RE: **TECHNICAL MEMORANDUM – SUPPLEMENTAL PROPOSED
MODIFICATION OF APPROVED SOURCE CONTROL MEASURES
ODOT FACILITY IN PORTLAND HARBOR PROJECT AREA**

TO: Jonathan Horowitz, PE, ODOT Project Manager
FROM: Kelsey Harpham, WSP Project Manager
SUBJECT: K22552: OF 16-1 and OF 18-2 SCMs
DATE: 19 March 2025

OF18-2
Option 1

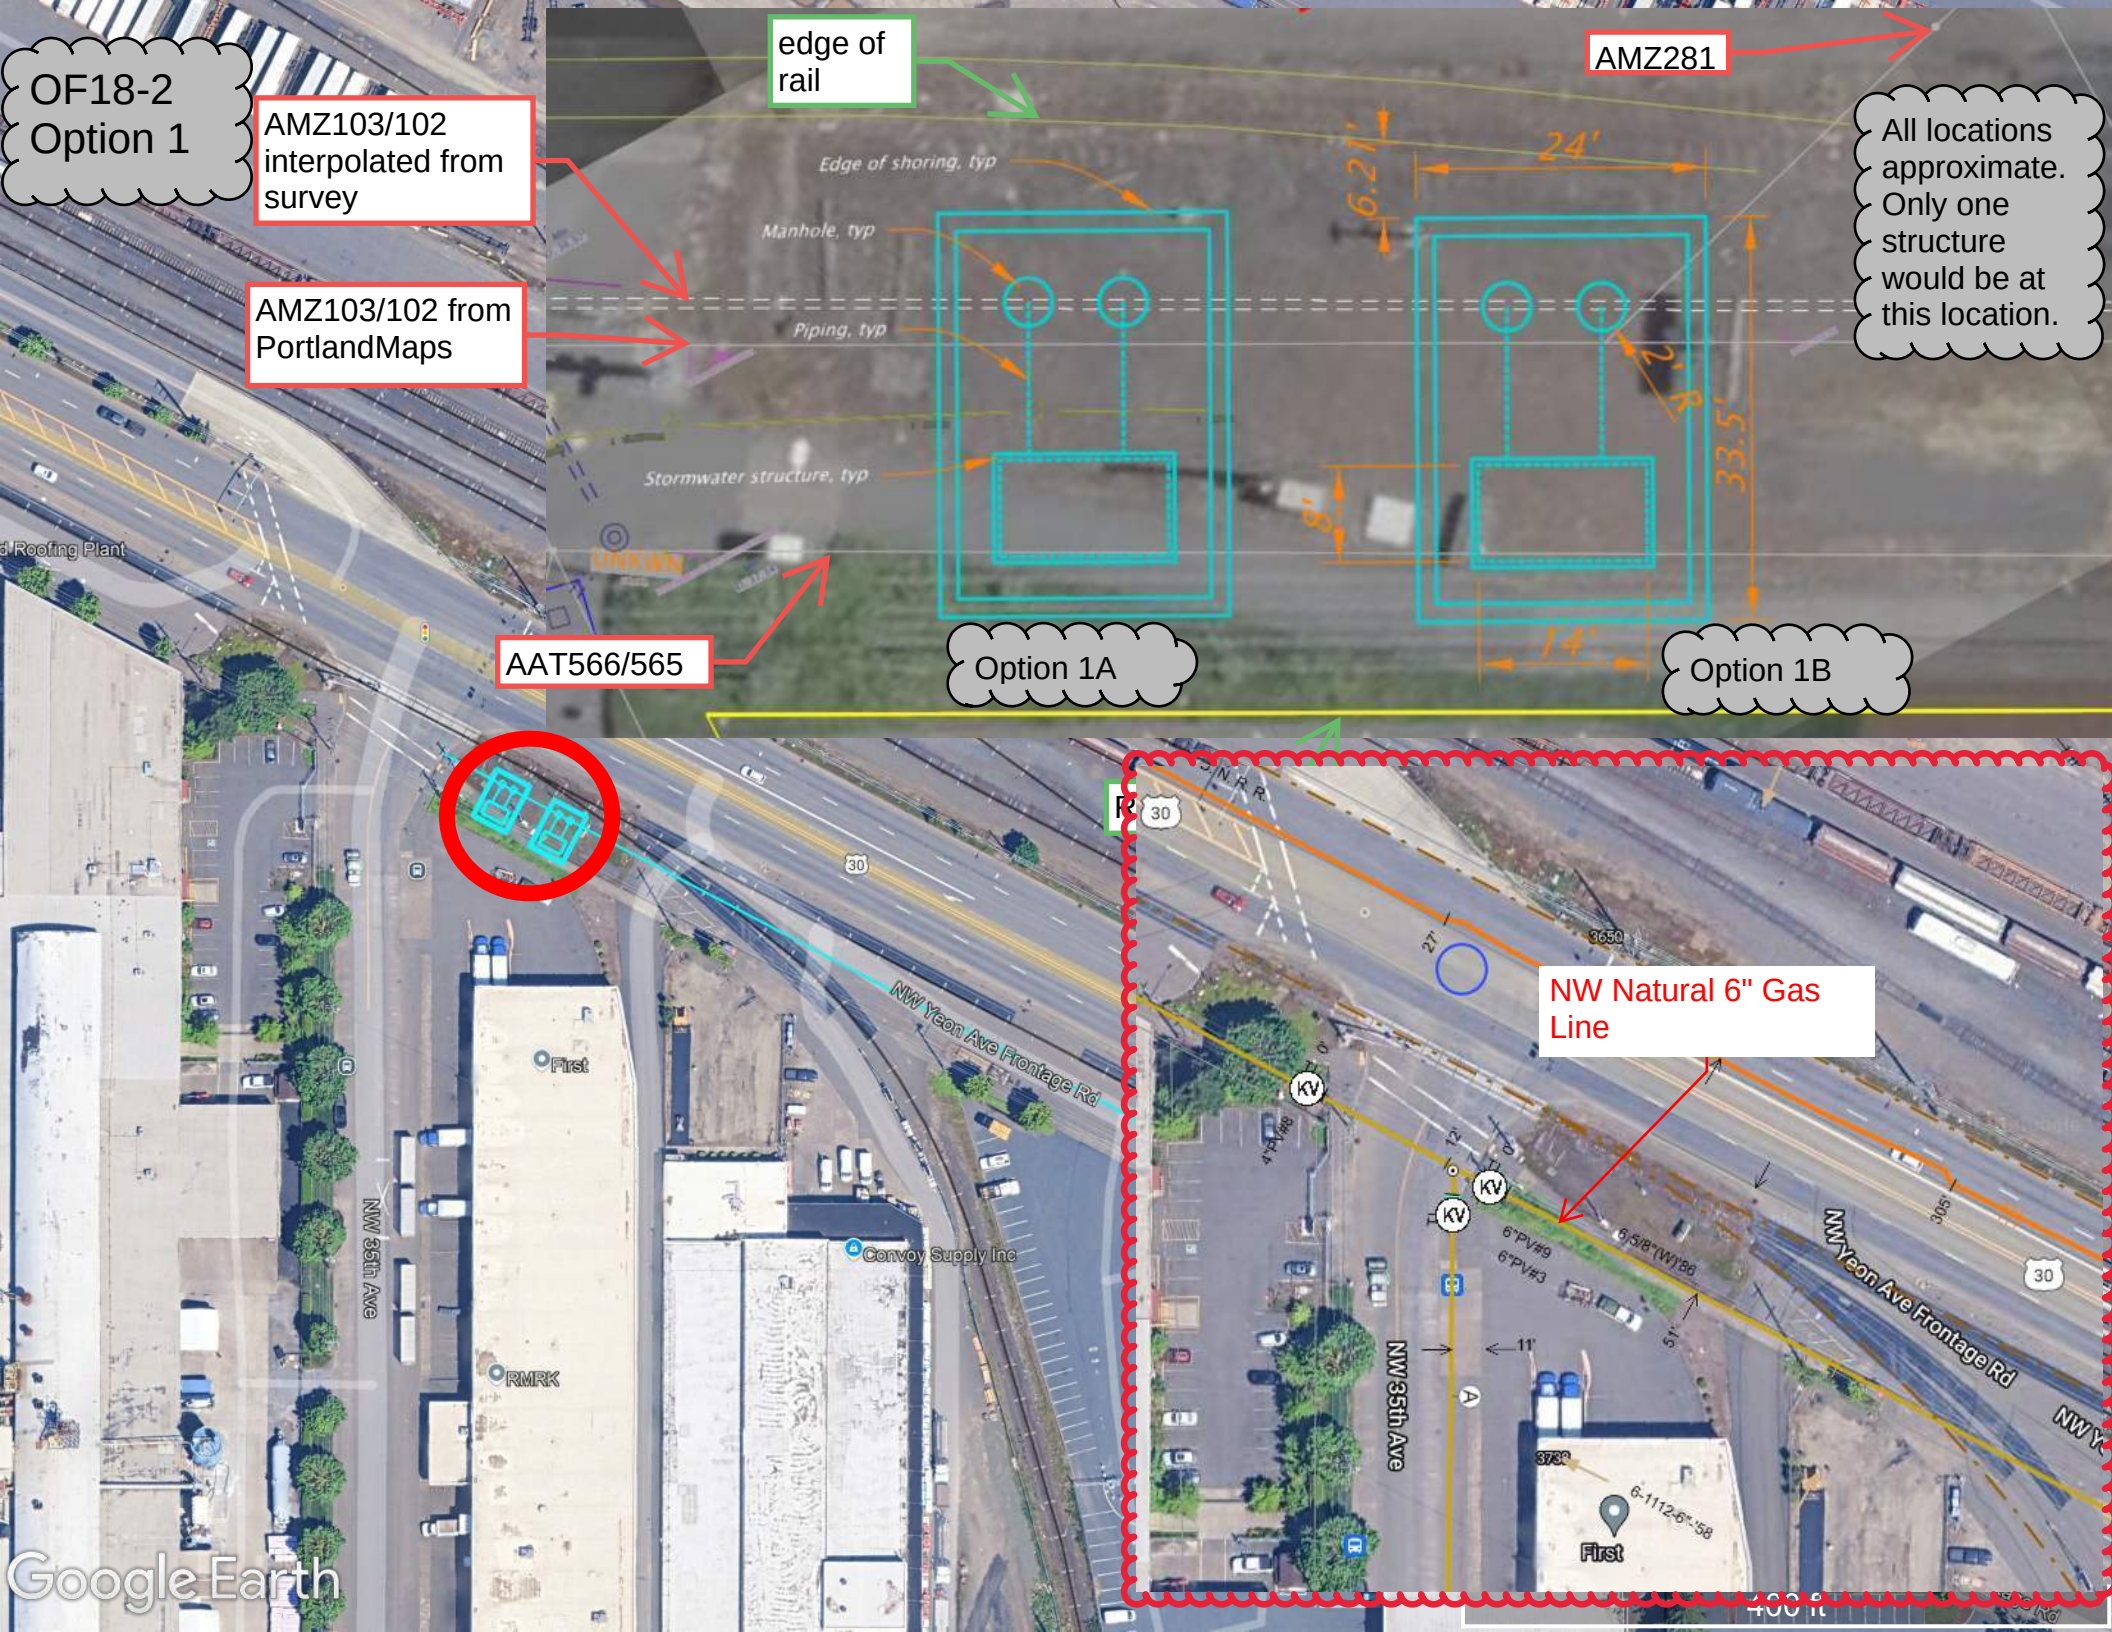
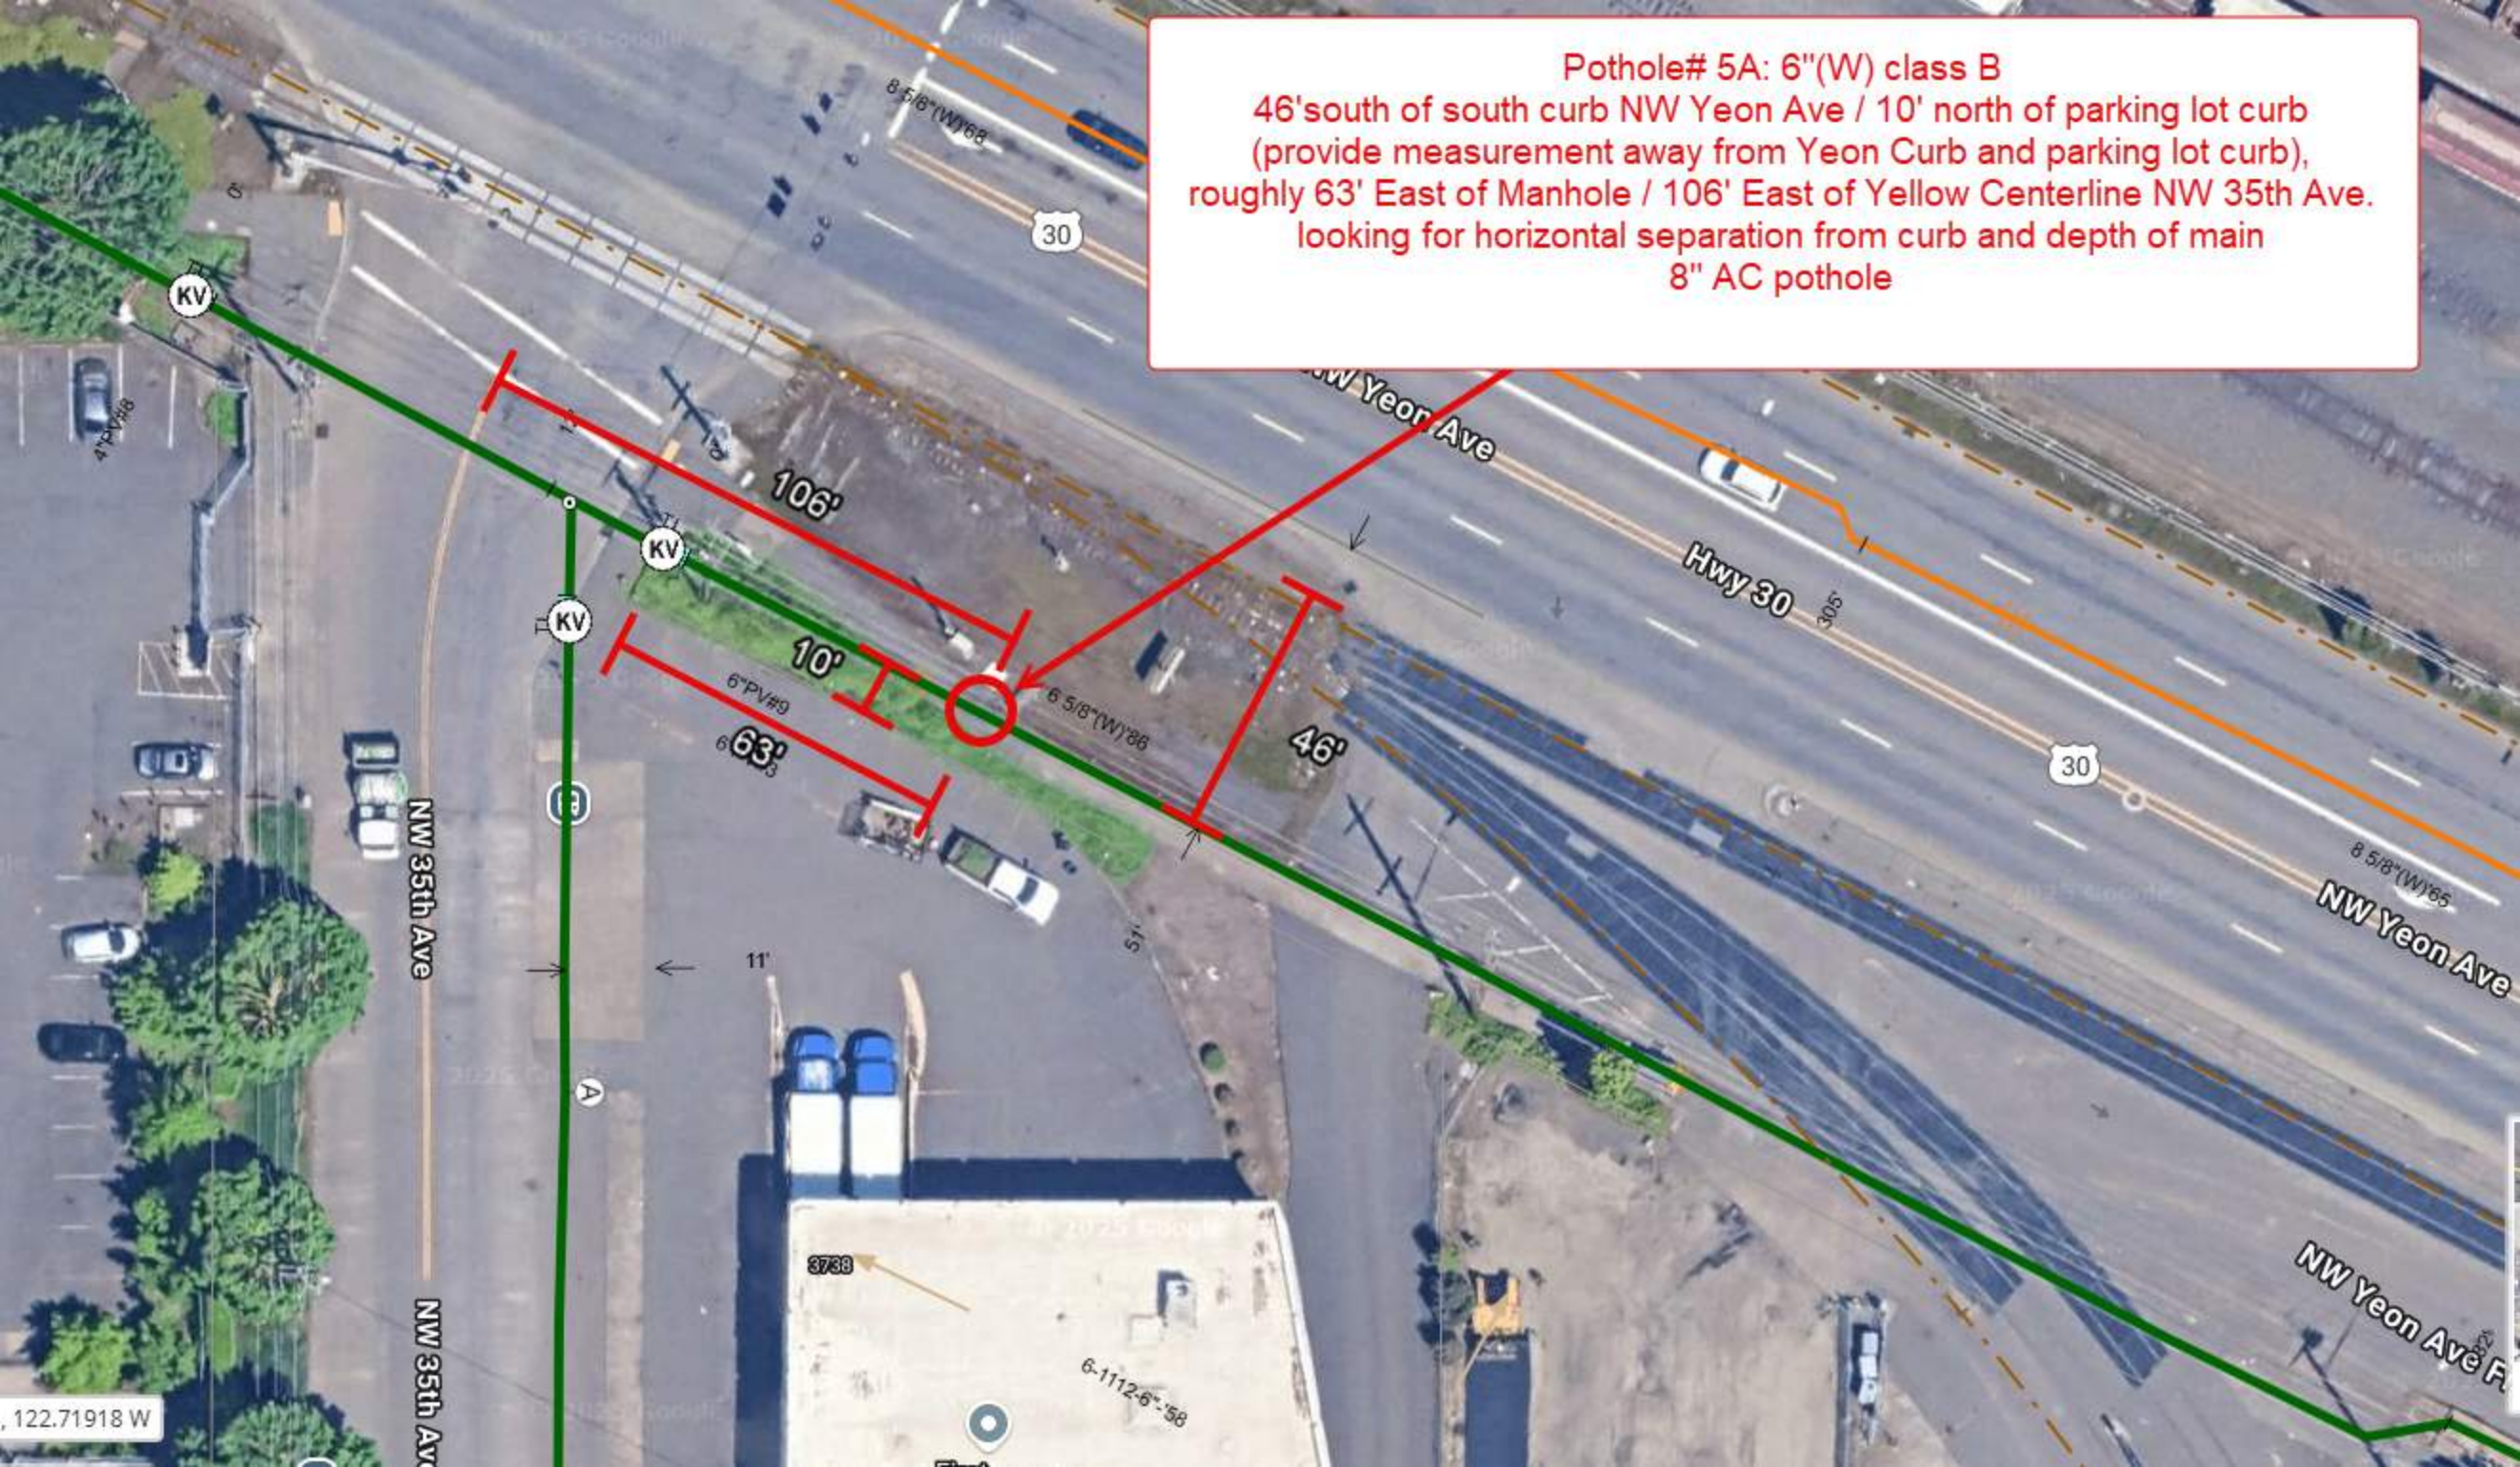
The proposed water quality structure at location 18-2 is one of two water quality structures in the OF 18 basin. The structure at 18-1 is a BioPod which treats 0.55 acres of ODOT area. In the Supplemental FS, the PHS structure at 18-2 was proposed to be located on the south side of US30 on NW Yeon Frontage Road. The project team originally designed the facility near this location. During Draft DAP review, coordination with rail indicated that the rail lines near the proposed location were inactive. However, during Final DAP, further coordination and design review revealed that the nearest rail line to the proposed location was active on a nightly basis. Construction requirements, including permitting, shoring, and flagging, made this location for the facility infeasible. Multiple alternative options were assessed, including:

Based on this analysis, the proposed location in the angled parking area near Prologis NW was evaluated with slightly higher scores than the alternative near the intersection of NW Yeon Ave and NW 35th Ave. The challenges at the site near NW 35th Ave, including utility conflicts and the need for acquisition of ROW, resulted in the slightly lower implementation risk score at this site. There is a slightly higher capital cost for the location near NW 35th Ave, but the treated area is also higher than the location near NW Prologis.

Based on the information provided above, the design team recommends the *removal of the PHS unit at 16-1, and moving forward with design and construction of 18-2 at the location near Prologis NW in the parking area*. The reduction in treated area is low compared to the cost savings and schedule implications of including the sites at either the 16-1 US30 location or at the intersection of NW35th and NW Yeon Ave. This recommendation is based on cost and schedule impacts as well as site constraints.
